**THIRD PARTY REVIEW
OF PROCEDURES AND INTERPRETATION
OF AIR INJECTION PERMEABILITY TESTS**

DRAFT

Prepared For:

Department of the Interior
U.S. Geological Survey
P.O. Box 25046 M.S. 425
Denver Federal Center
Denver, Colorado 80225

FIGURE 1

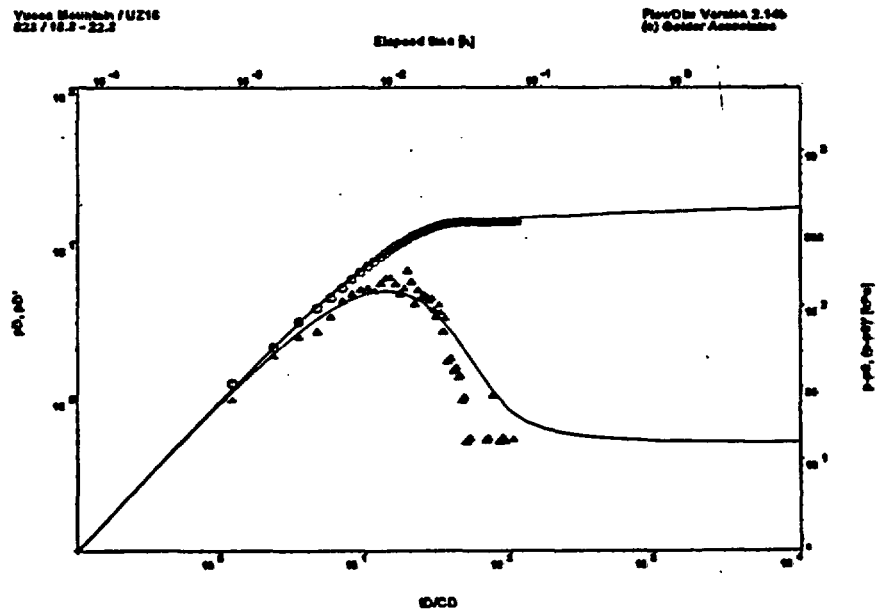
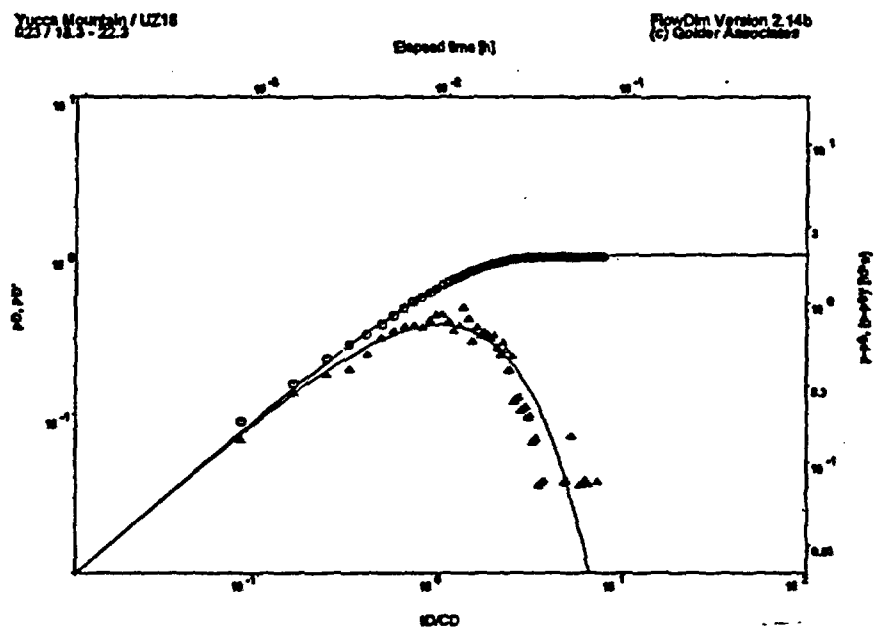
Figure 1(b) shows the type-curve analysis for the same test (60' - 73'; Tiva Canyon) using p^2 as the dependent variable. The overall match is not significantly better than that obtained with the p-

based approach. It seems that for the pressure disturbance imposed during this test either linearization approach is equally valid. As pointed out earlier, although the "pressure" versus time curve seems to match closely the type curve, the pressure derivative clearly shows the discrepancy and the lack of match between the data and the radial flow model. A type-curve match for the same data and the spherical flow model is presented in Figure 2. The match for both the pressure and pressure derivative are superior with this model. One must admit, however, that a slightly longer test would have provided the necessary evidence to categorically reject the radial model. In fact, this is the case for the test with a higher flow rate in the same location (Figure 3). In this instance, the radial flow model can be categorically discarded because enough data was collected beyond the point where pressure stabilization for such model is expected (notice the flattening of the type curve at $p_D = 0.5$ in Figure 3a). Indeed, Figure 3(b) shows a very good match between the data and the spherical flow model. Estimated permeability values and skin factors for all these tests are reported in Table 1. Notice that the reported skin values for the spherical flow model are much smaller than those from the radial flow model, and much more smaller than those reported by ARI.

FIGURE 2

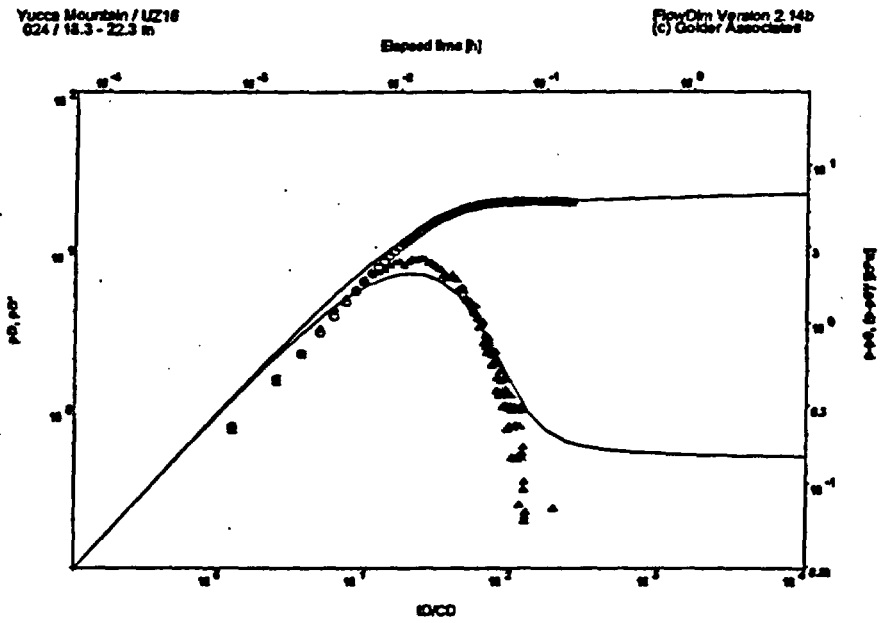
The test interpretation performed by ARI resulted in permeability values and skin parameters which are generally much larger than those estimated by the USGS. For instance, air permeability for the test in the Tiva Canyon member at a depth between 60' to 73' (Figure 2, from ARI 1994) is 210 Darcies with a skin factor of 135, whereas the USGS permeability estimate is 2.1 Darcies. In order to study such a large discrepancy, we re-interpreted the same test using the FLOWDIM code. Figure 1(a) shows the field data and the corresponding type curves for the radial flow case. Notice that the match between the derivative data is relatively poor for "late" times within the test, just as that shown in Figure 2 from ARI (1994). However, the estimated permeability and skin factor are different to those reported by ARI (see Table 1). Our estimates are 21 Darcies and 8.1 for permeability and skin respectively. It must be noted that we used the same porosity, average fluid compressibility, air viscosity, temperature and gas deviation factor as reported by ARI (page 4 in their 1994 report). When the ARI estimated values for dimensionless compressibility and skin are substituted to compute the type curve parameter $C_d e^{2s}$, one obtains a value of 10^{120} ! This value is far beyond the typical maximum value (10^{30}) reported in the oil and gas literature (see for example Bourdet et al., 1983). Our best match in Figure 1(a) is obtained with a $C_d e^{2s}$ of 10^{10} . It is interesting to notice that all $C_d e^{2s}$ values computed from ARI's 1994 report are between 10^{60} and 10^{200} with the majority over 10^{100} .

FIGURE 4

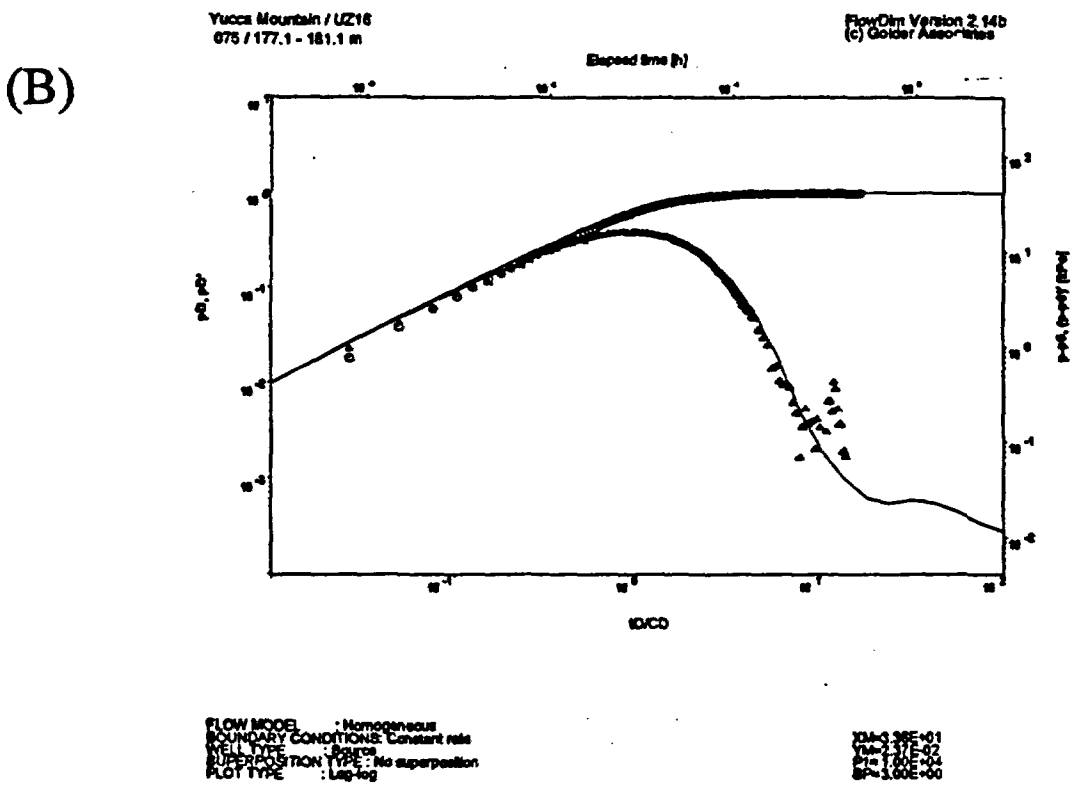
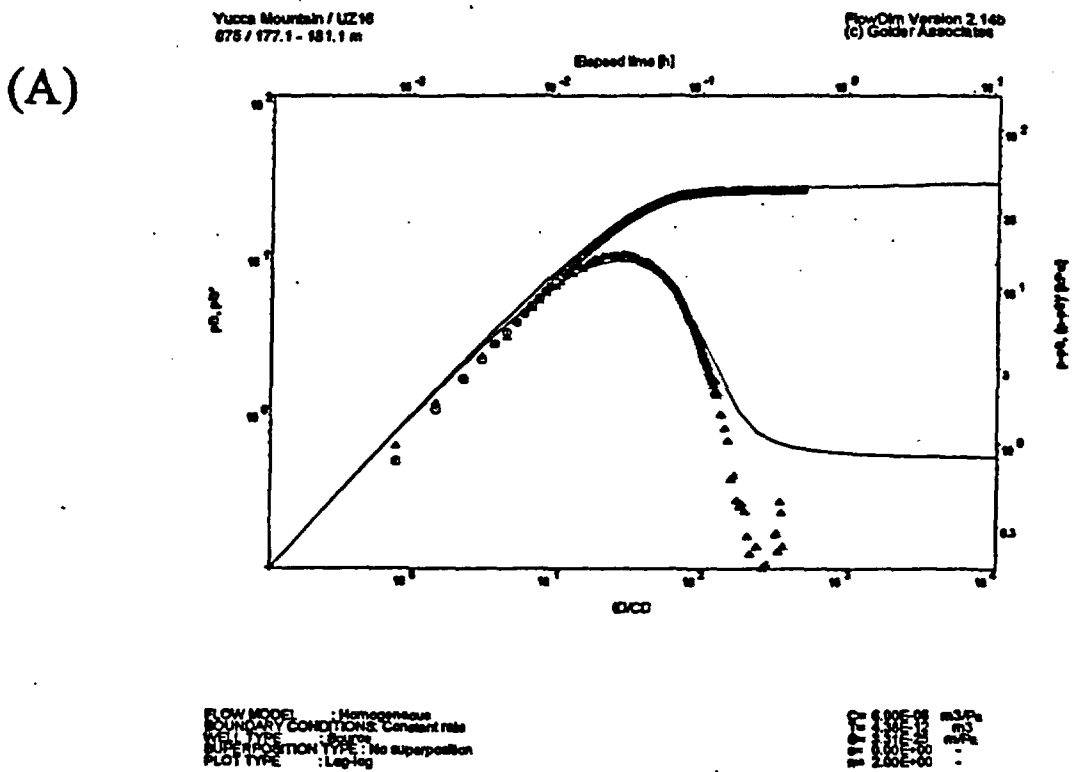
One other test (UZ-16-075) between depths 177.1 and 181.1 m was analyzed with FLOWDIM. Figure 4(a) shows the radial flow type curve match, whereas Figure 4(b) shows the spherical flow type curve. From figure 4(a), one can discard radial flow as an option for interpreting this test. Once the derivative decreases sharply beyond 0.5, the radial flow model is not a candidate anymore. Figure 4(b) shows a nice fit to both the pressure and the derivative data. The skin factor for these models are 32.3 and -0.35 for the radial and the spherical model, respectively. These latter values clearly illustrate the concept of pseudo-skin in the case when the wrong model is selected.
